DART AEROSPACE LTD		Work Order: 164204
Description: Crosstube Assembly		Part Number: D407-667-145
Inspection Dwg: D407-667-145 Rev: C		Page 1 of 2

DRAWING NO. D407-667-145	TITLE CROSSTUBE ASS'Y (407 HIGH FWD)	REV. C	DART AEROSPACE LTD ENGINEERING ORDER		D.E.O. NO. D407-667-145-C-1	SHEET NO. SHEET 1 OF 1	SCALE NTS
DRAWN <i>q</i>	CHECKED <i>ASS</i>	MFG. APPR. <i>18</i>	APPROVED <i>WD</i>		DE APPR. <i>#</i>		
DATE 11.07.15	DATE 11.07.22	DATE 11.07.22	DATE 11/07/22		DATE 11.07.21

DRAWING NO. D407-667-145	TITLE CROSSTUBE ASS'Y (407 HIGH FWD)	REV. C	DART AEROSPACE LTD ENGINEERING ORDER	D.E.O. NO. D407-667-145-C-2	SHEET NO. SHEET 1 OF 1	SCALE NTS
DRAWN AJS	CHECKED <i>[Signature]</i>	MFG. APPR. <i>[Signature]</i>	APPROVED <i>[Signature]</i>	DE APPR. <i>[Signature]</i>		
DATE 12.08.02	DATE 12.08.02	DATE 12.08.02	DATE 12.08.02	DATE 12.08.02	DATE 12.08.02

ADD ELECTRICAL GROUNDING STRAP

DETAIL P
BONDING STRAP INSTALLATION 2 PL

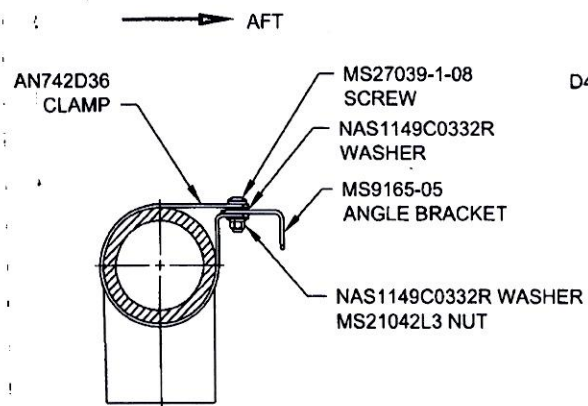
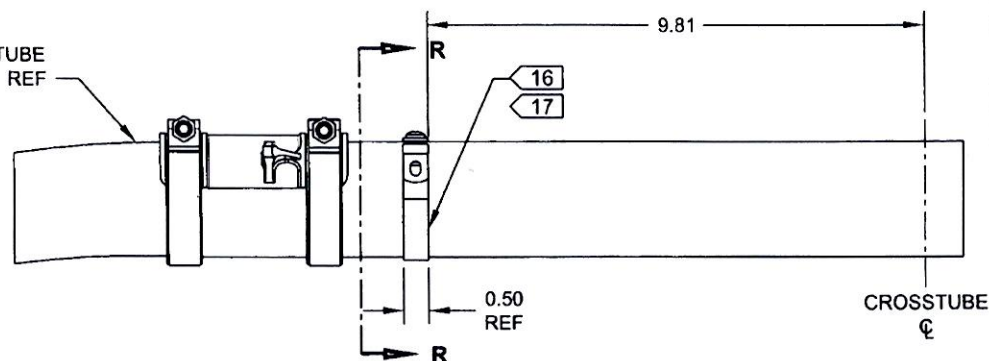
ITEM	QTY -145	PART NUMBER	DESCRIPTION
1	X	D407-667-145	CROSSTUBE ASSEMBLY (407 HIGH FWD)
10	2	AN742D36	CLAMP
11	2	MS9165-05	ANGLE BRACKET
12	2	MS21042L3	NUT (OR MS21042-3)
13	2	MS27039-1-08	SCREW
14	4	NAS1149C0332R	WASHER (OR AN960C10L)

- 16) MASK AREA UNDER CLAMP PRIOR TO PAINTING
- 17) SEAL EDGES WHERE AN742D36 CLAMP MEETS WITH THE CROSSTUBE USING SIKAFLEX-241/-291 OR MIL-S-8802 CLASS B2 OR PROSEAL 890 SEALANT
- 18) PERFORM RESISTANCE CHECK TO ENSURE MAX RESISTANCE IS 10 MILLIOHMS
